UNITED STATES PATENT AND TRADEMARK OFFICE

APPLICATION NO.	FILING DATE	FIRST NAMED INVENTOR	ATTORNEY DOCKET NO.	CONFIRMATION NO.
10/002,563	11/01/2001	Maria Cristina Moret Codina	1863	3781

Office Action Summary

DETAILED ACTION

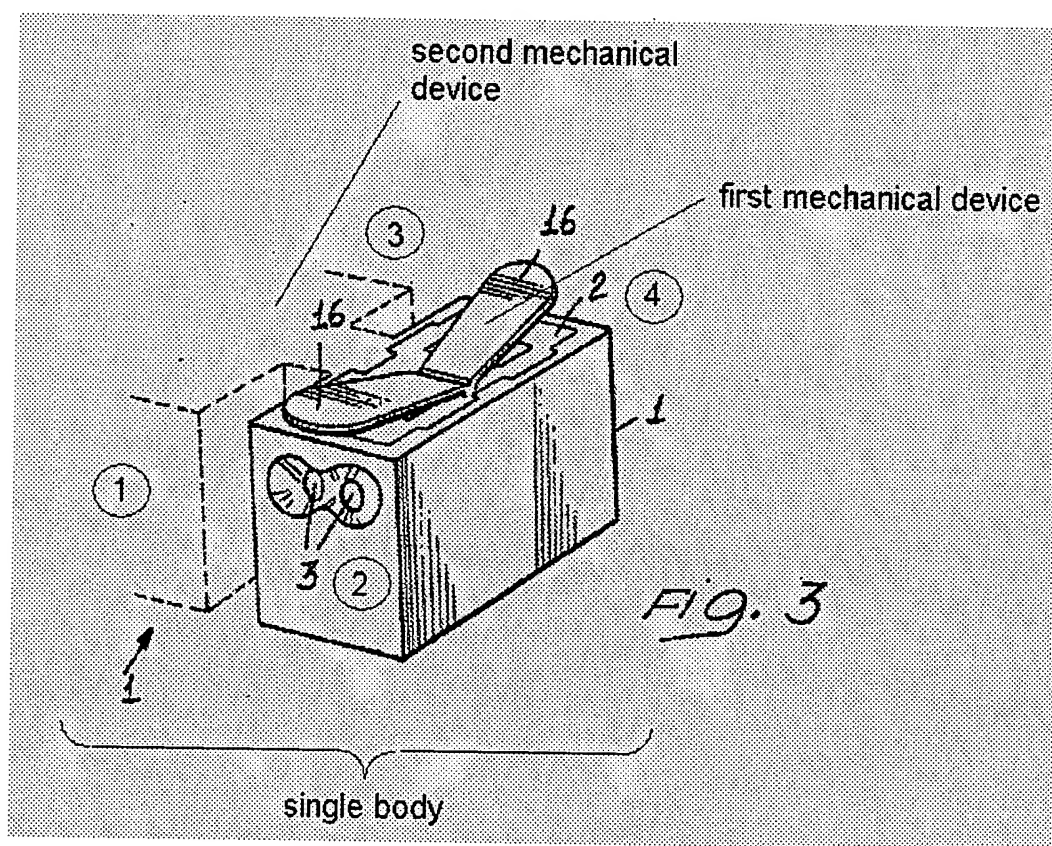
Gelati discloses a unit for quick connecting conductors to terminals, comprising: a single body (1,1) in which two conductors (5) are introducible, at least two mechanical devices (16,16) accommodated in the single body and each formed and operative for a quick connection of one to the conductors (5) and a disconnection of the one conductor from each terminal without impairing the other of the mechanical devices and the other conductor, so that each of four conductors can be connected or disconnected individually and separately from one another. Gelati also teaches each of the mechanical devices including an operating lever having two identical and independent levers (16,16 in Fig.6) symmetrically located with respect to a contact plane and provided with a top flat base, and ending in a rounded lower end (tip of 17) and a stop latch (side of 17); side holes (3) and a lower part.

Regarding claim 4, Gelati also teaches a bottom and the metal strip supported on the bottom.

Regarding claim 6, Gelati discloses an elastic metal band (6) having two top divided parts (8) under the levers and arranged symmetrically and independently, and

two contacting bases (bottom of holes 3 in Fig.4) which are formed symmetrical and independently.

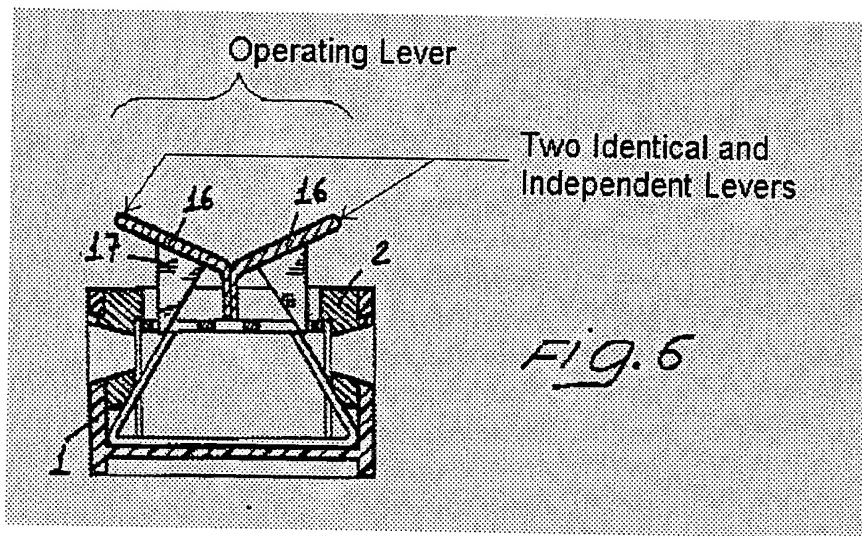
Applicant's arguments filed February 23, 2004 have been fully considered but they are not persuasive.

In response to applicant's arguments (filed 02/23/04) regarding Gelati, please refer to the following Figure.
